Response to Draft CDF SAM Requirements !DRAFT!

Adam Lyon, July 20, 2005

CDF has released draft expectations for SAMGrid in the form of a requirements document (sent via e-mail on June 30, 2005 and reproduced verbatim in Appendix A). The summary of DC rate expectations is shown in Table 1.

Fig. 1. DØ SAM world wide project start rate (starts per day) for 7/1/04-7/1/05.

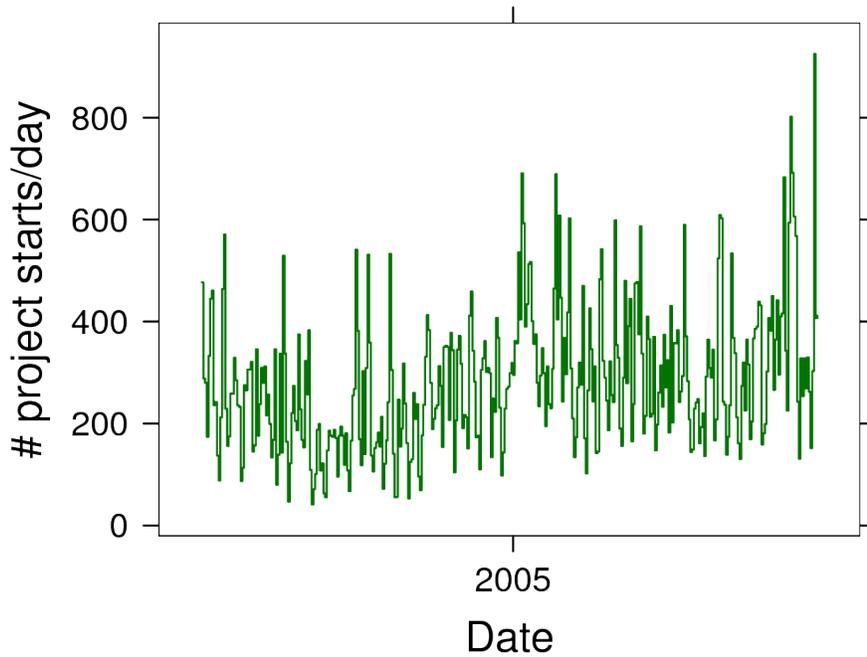
The mean number of project starts per day is 282.8 per day or 0.0033 per second. The maximum number of starts per day is 925 per day or 0.011 per second. The maximum number of project starts is 93 times less than the claimed CDF DC expectation.

The expected number of DC project starts appears to be excessively high; 306 times the mean rate that DØ achieves world wide. Perhaps what was really meant was *process* starts - that is SAM servicing a job segment instead of a group of segments. Process starts will be examined next.

Fig. 3. The DØ process start rate for the period 7/1/04-7/1/05.

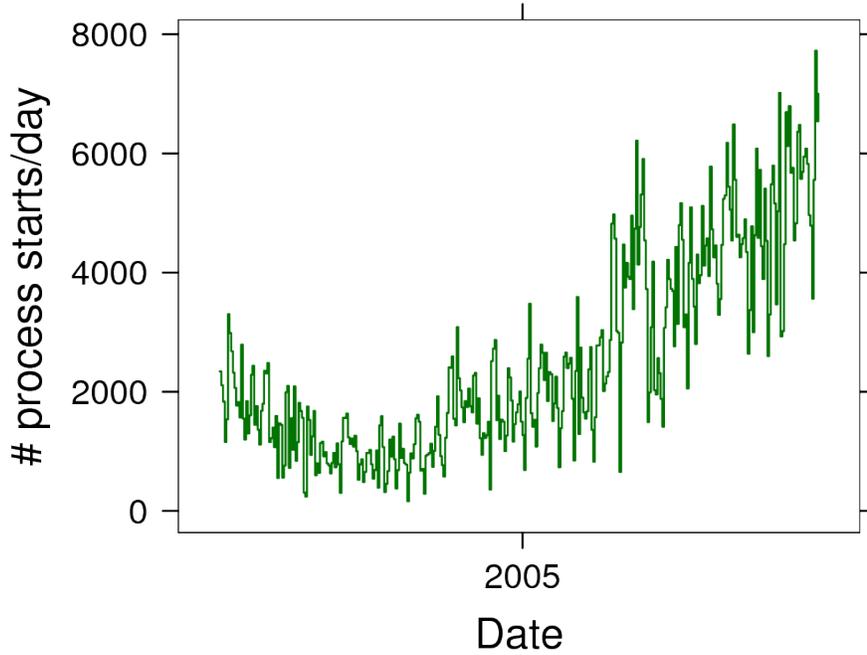
At around the start of 2005, the rate looks to be steadily increasing. To understand this effect the data are split by the servicing DB server. That plot is shown in Fig. 4. One clearly sees the start of the DØ reprocessing effort in late 2004 – early 2005. The Farm, Grid, and Station DB servers all service stations involved in the reprocessing effort. Note that the central-analysis station was discontinued at the start of 2005.

Assume that the CDF expected project start rate is really the *processs* start rate. The DØ world wide maximum process start rate is 7722 process starts per day, or 0.09 per second. The CDF expectation of one process start per second again seems excessively high (11 times higher than the DØ rate). We request that CDF produce a plot how many job segments actually start per second (not how many *can* start, but how many actually do, over the past year). We think that will give a better idea of the CDF load. Certainly the DØ load has increased significantly over the past year (about a factor of 4), and SAM has been able to keep up.

Fig. 6. Total number of files consumed per day for DØ for the period 7/1/04 – 7/1/05.

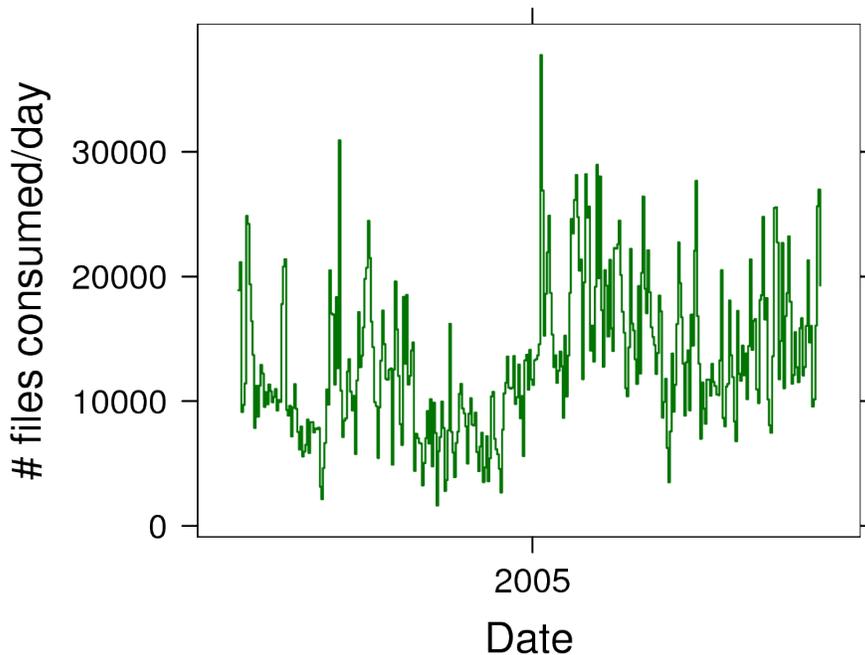
Fig. 6 shows the total world-wide file consumption rate (# files per day). The mean number of files consumed is 13192 per day (0.15/s) and the maximum is 37759 per day (0.44/s).

The CDF expected file consumption rate is 52 times larger than the mean DØ rate and 18 times larger than the DØ maximum. Note that the DB server probably has very little to do with a limit on this rate -- rather it is the load on the station, disks, tapes, and network infrastructure. CDF obtained this expectation from the maximum dCache delivery rate. It would be more realistic to measure the CDF file input rate directly and compare.

Fig. 9. DØ world wide file storage rate (including storing to durable locations). File stores/day.

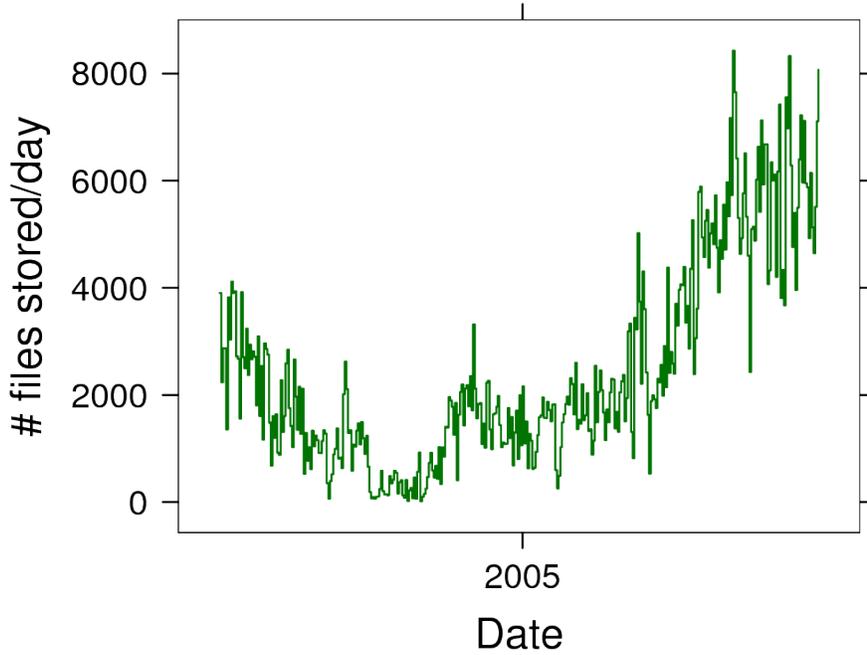
Fig. 9 shows the world wide DØ file storage rate. As in the process rate, the plot is increasing steadily after the start of 2005. Looking at how the file stores are broken up among DB servers, it is clear that the DØ reprocessing is causing the rise. See Fig. 10. Note that dlsam is the online raw file storage.

The mean DØ file store rate is 2471 files per day (0.029/s) or 0.9 TB/day. The maximum DØ file store rate for the period is 8425 files per day (0.098/s) or 2.6 TB/day. The values include all MC, raw data, processing, reprocessing and user file stores, including intermediate MC and merging files. The CDF expectation of 50 file stores per second is 1748 times the DØ mean rate and is 513 times the DØ maximum rate. only caveat is that DØ tends to store files as the jobs go along, instead of waiting until the very end. If CDF plans to store files in bursts, they would be well advised to consider the DØ method.
